ATTACHMENT C

Comments on Cumulative Impact Assessment, Subsidence Assessment, Surface to Seam Fracturing Assessment, Geological Structures Assessment, Impact on Coastal Upland Swamps

Dendrobium Mine Extension Project EIS (SSI-33143123)

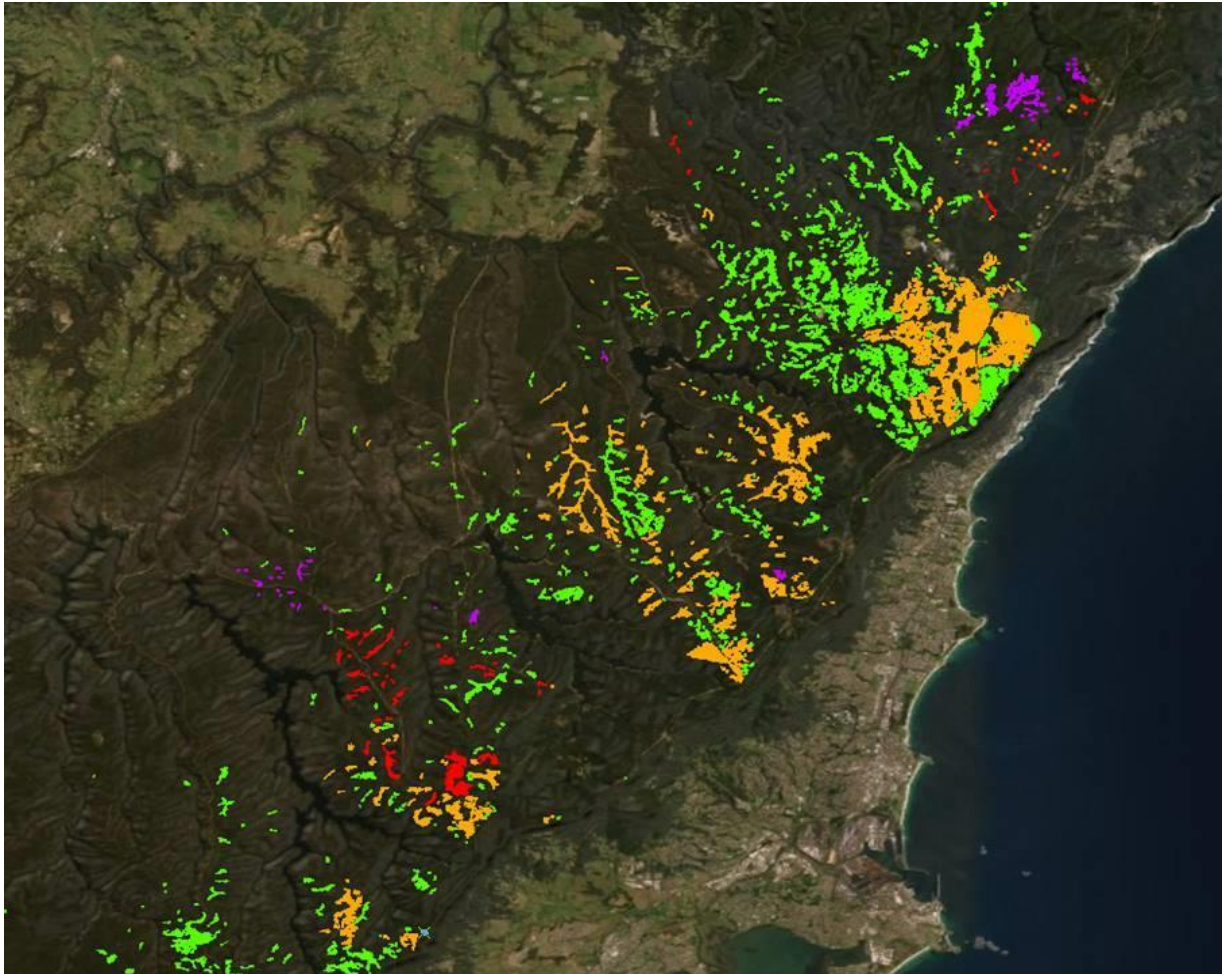
Other mines (e.g. Elouera Mine, Russel Vale Mine, Metropolitan Mine) have also impacted Coastal Upland Swamps on the Woronora Plateau and their contribution to the cumulative impact to the Upland Coastal Swamp TEC should be added to that of the swamps already impacted by Dendrobium Mine, together with those proposed to be impacted by the current Dendrobium Area 5 proposal⁶. The Science Economics and Insights Division (SEI) of the Department of Planning and Environment are currently reviewing all such impacts and the current best estimate of impacted swamps is contained in Table 1. The location of these putatively impacted swamps is illustrated in Figure 4. It should be noted that the swamp area estimate is subject to the mapping procedures used and that these numbers and maps are currently a work in progress. SEI is continuing to refine these numbers/areas. Nevertheless, the obvious break in continuity in the landscape due to Elouera and Dendrobium impacts (red areas; bottom left in Figure 4) is notable. Approving further destruction of Area 5 swamps⁷ will simply increase this disconnection.

It is noted that the current 2022 Dendrobium Area 5 longwalls are likely to irretrievably alter the hydrology of an estimated 17 Ha of upland swamp (Table A1, Appendix A), although Niche have discounted⁸ this area to ~9 Ha. It is noted that Niche's (2022) mapping has not been validated or peer reviewed and they have not followed the NSW Government Swamp Offsets Policy which requires offsetting of the entire area of the swamp (not an unvalidated proportion of the swamp).

Area (Ha)	Number of Swamps	Percentage of Total Area
Total Undermined Impacted	194	54	3.66%
Total Proposed Undermining	151	43	2.85%
Total Undermined, Impact not known	1921	198	36.2%
Total Impacted by mine water	N/A	1	
Total Swamp Area (OEH)	4729		
Total Swamp Area (Fryirs and Hose 2016)	2568		
Total Swamp Area (OEH & Fryirs & Hose 2016)	5294	1000+

Figure 5. Modelled flow exceedance curves. Source HEC (2022).

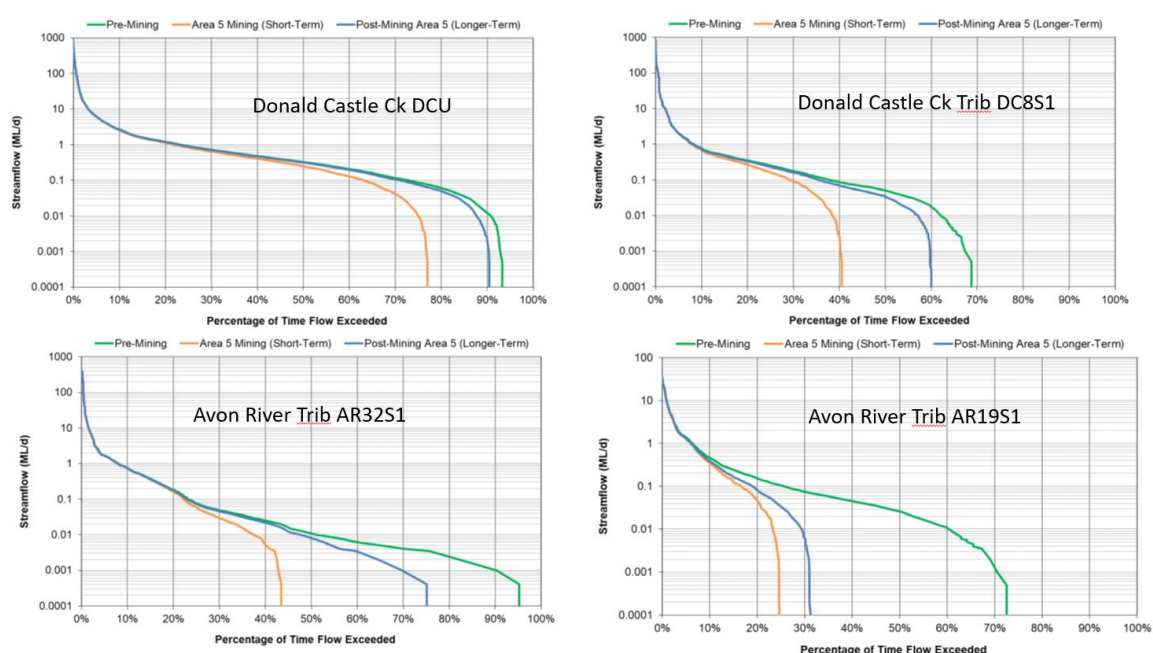
Modelling for the EIS has often been in a perpetual state of 'calibration' and in many cases these models have not been properly validated. HEC (2022) provided several modelled flow

exceedance curves which identify significant stream flow losses for potentially affected streams above Area 5. No similar assessment is included for the streams that have already been impacted (apart from Donalds Castel Ck at DCU) and there is no provision of modelled versus measured flow data that demonstrates a validation of the modelled flows; or any assessment of the uncertainty in model estimates. The modelling presented (see Figure 5) suggests a:

- 'short-term'¹⁰ 20% increase in the cease to flow period in DCU
- 'short-term' 30% increase in the cease to flow period in DC8S1
- 'short-term' 50% increase in the cease to flow period in AR32S1
- 'short-term' 50% increase in the cease to flow period in AR19S1
- 'short-term' 30% increase in the cease to flow period in LA13S1
- 'short-term' 55% increase in the cease to flow period in LA8S1

The '*longer-term*' Post Area 5 increases in cease to flow conditions illustrated in Figure 5 are largely dependent on unvalidated model assumptions, are subject to high uncertainty and may take centuries to eventuate (if at all). It is additionally noted that much of the flow data for this area lacks adequate baseline characterisation, does not adequately consider flow impacts during drought conditions¹¹ and have not considered historic impacts (e.g. loss of flow in Wongawilli Creek and other streams due to earlier Elouera fracturing and losses of tributary flows).

What is clear is that the losses illustrated in the Surface Water Assessment will be in addition to the already significant surface water losses experienced due to past mining impacts at Dendrobium (and on the Woronora Plateau more broadly). It has also previously been identified that a proportion of surface water losses are going into the Dendrobium Mine itself (PSM 2019, IEPMC 2019a,b) and this is likely to continue for the foreseeable future.

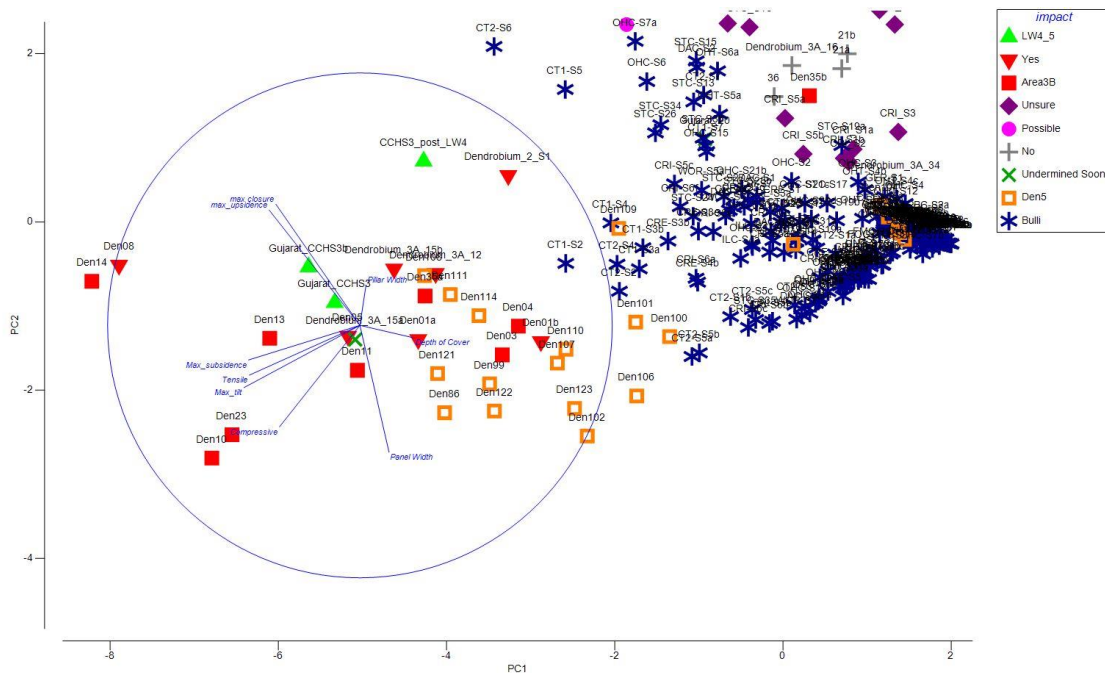
Rather than re-calibrating the IPM to take account of the wider longwalls currently being used, MSEC currently use a somewhat arbitrary factor to adjust subsidence predictions based on older IPM results (using either 30% for Area 3B or 12% for Area 5). This approach has not been well validated and will obviously lead to lower predicted subsidence levels for Area 5 than those in Area 3B (despite the similar mining dimensions and conditions; depth of cover, longwall width-to-depth ratios and mining heights). Given that lower accuracy (ALS) subsidence survey measurements have been used to assess model fit, there is a distinct possibility that subsidence levels for Area 5 have been underestimated.

These values are stated to be *the maximum predicted subsidence effects within 20 m of the mapped extents of each of the swamps*. The obvious inconsistency in stating 15 % of the stream controlling features located within 400 m of the proposed longwalls could experience Type 3 impacts but only considering *the maximum predicted subsidence effects within 20 m of the mapped extents of each of the swamps* potentially leads to a significant underestimate of impact for some swamps above or near Dendrobium Area 5 longwalls. Swamps are effectively sediment filled and vegetated streams in these areas and therefore subject to the same subsidence processes as streams in other areas of the mine plan.

This summary misses the obvious impacts to Swamp 15b in Area 3A and Den08 in Area 3B. It also fails to provide any detailed discussion of risk (consequence and likelihood) of impact in relation to quantitative subsidence predictions, even though MSEC developed these predictions for individual swamps above Area 5. Using past MSEC predictions for Coastal Upland Swamp TECs and identifying swamps that have already been impacted; and then comparing current subsidence predictions for swamps in Area 5; all swamps above the 305m longwalls are almost certainly going to be fractured and drained (see Krogh 2013; Cardno's 2022 review of swamp impacts; and Figure 7). A more detailed assessment for Area 5 swamps at risk of impact is provided in Table A1, Appendix A).

Figure 8. Geological structures (faults, dykes and lineaments) mapped by PSM (2022; right) and MSEC (2022; left).

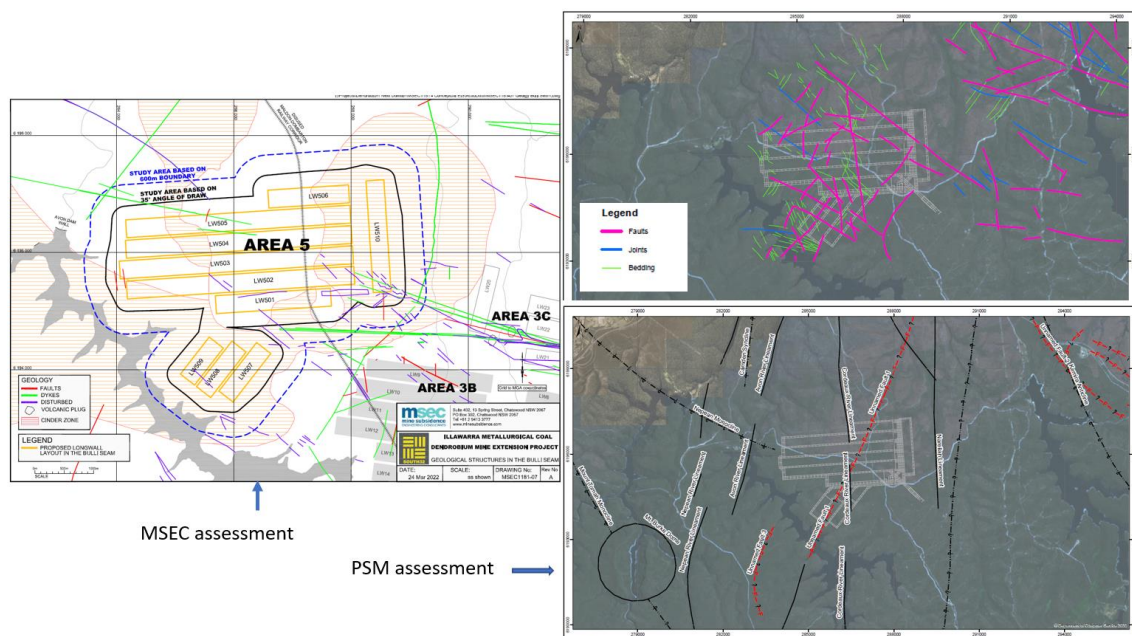
There is a significant discrepancy in what PSM (2022) assessed in terms of geological structures in Area 5 and that used by MSEC (2022) in their impact assessment - the latter missing almost all PSM mapped structures (particularly the Cordeaux Lineament and Unmapped Fault 1 - see Figure 8). Geological structures potentially have a significant role to play in impacts and consequences (especially for swamp and stream fracturing and drainage), including impacts extending a great distance away from the longwalls. On the Newnes Plateau the interaction of subsidence with geological structures (lineaments) led to impacts up to 2km away from the advancing longwall face (Springvale Expert Panel, MSEC 2021). It is possible that Type 3 pool impacts up to 400 m from longwalls identified by MSEC could be related to geological structures. Very little scientific data is provided to prove that geological structures do not interact with subsidence in the areas above Dendrobium mine (or the Southern Coalfield more generally). MSEC's portrayal and assessment of geological structures is considered to have serious shortcomings.

- The issue of geological structures (including faults, dykes, lineaments and joints) interacting with subsidence leading to adverse outcomes should be referred to the Independent Mining Panel for further detailed consideration.

Figure 9. Seepage rate predictions for swamps above Area 5 (HEC 2022 above) and observed swamp level responses impacted by previous longwall mining in Area 3B (HGEO 2022).

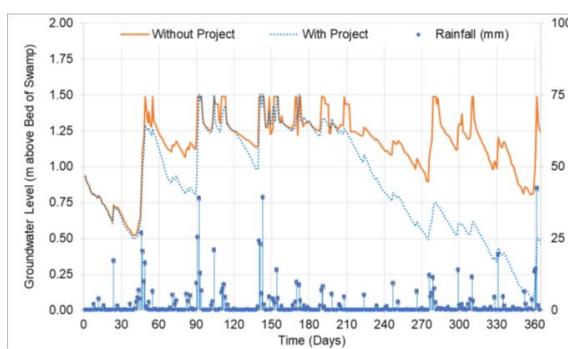
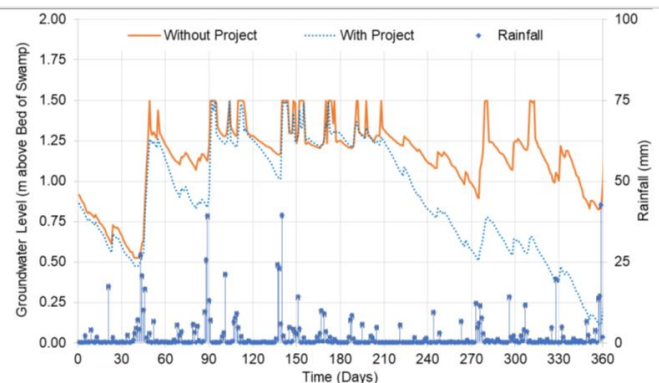
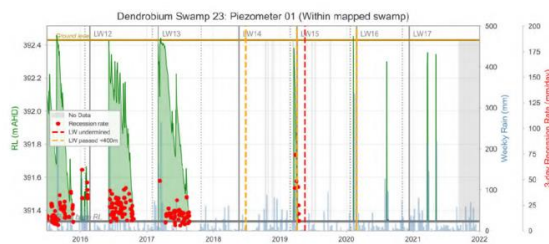
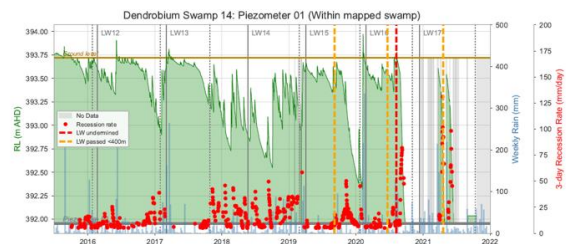
Very little justification is provided for the horizontal and vertical hydraulic conductivities used in the model (Table 18) or the uncertainty/sensitivity of the model to these conductivity values.

The methodology described in the HEC (2022) falls well short of an adequate model calibration (based on only 5 months data for one swamp in 2017) or validation. Of major concern is the obvious lack of agreement between modelled seepage rates (and swamp levels) and that observed for impacted swamps above Dendrobium Area 3B (e.g. see Figure 9). Multiple documents including End of Panel Reports for Area 3B identify longwall mining impacts cause the complete drainage of upland swamp TECs with only the occasional rise in swamp levels in response to intense rainfall events before water levels subsequently drop below the bedrock base of the swamps (e.g. Krogh 2014, Young 2017; HGEO 2022, Cardno 2022). HEC's model does not replicate this behaviour and clearly does a very poor job at predicting water levels in swamps that are impacted by longwall mining. It is not therefore considered fit for the purpose of assessing mine impacts on swamps in Area 5 or drainage rates in the underlying bedrock.

- The HEC (2022) seepage model should not be used as a reliable point of reference for this assessment and the model and its predictions should be referred to the Independent Mining Panel for more detailed consideration.
